**Jersey Street RFP Addendum 1**  
RFP Issue Date: November 3, 2023  
Pre-submission Conference Date: December 5, 2023

Addendum 1 Issue Date: December 20, 2023

### C. Appendix M Supplement Diagram

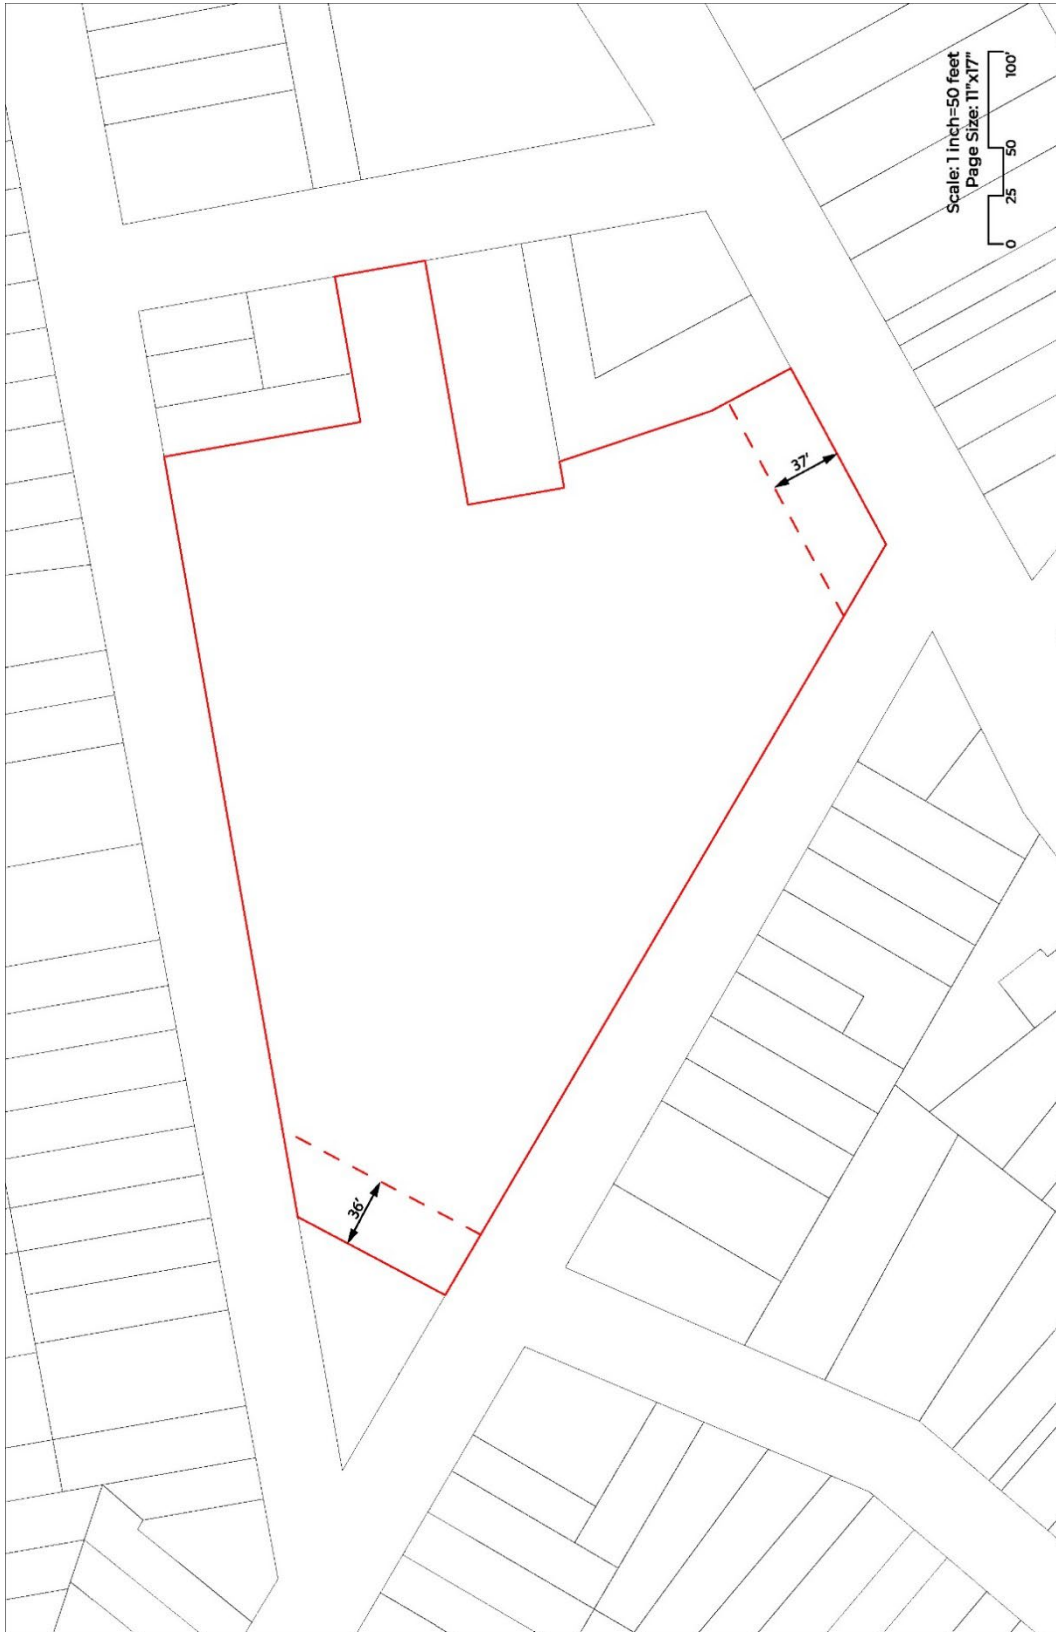
- 14. A. Should the project zoning lot be considered to reach the current street line on Victory Blvd. or the street line after the proposed street widening (indicated on the NYC Digital Tax Map) and is the proposed public space expected to coincide with the street widening?**

**B. Should the street widening indicated on the NYC Digital Tax Map along the Victory Blvd frontage be respected for site planning?**

- 15. Should the street widening line be considered the street line for height and setback purposes in the zoning?**

The zoning lot should be considered to reach the current street line on Victory Blvd and include the street widening area. For the purposes of this RFP, development teams should use the lot dimensions drawn in Form M, which were determined from ZoLa.

Additionally, for the purposes of this RFP, respondents should treat the Victory Blvd widening line (as shown in Section C of this addendum) as the lot boundary for measuring any applicable bulk regulations such as base height and setbacks.

Yes; for the purposes of this RFP, respondents should treat the Victory Blvd widening line (as shown in Section C of this addendum) as the lot boundary for measuring any applicable bulk regulations such as base height and setbacks.
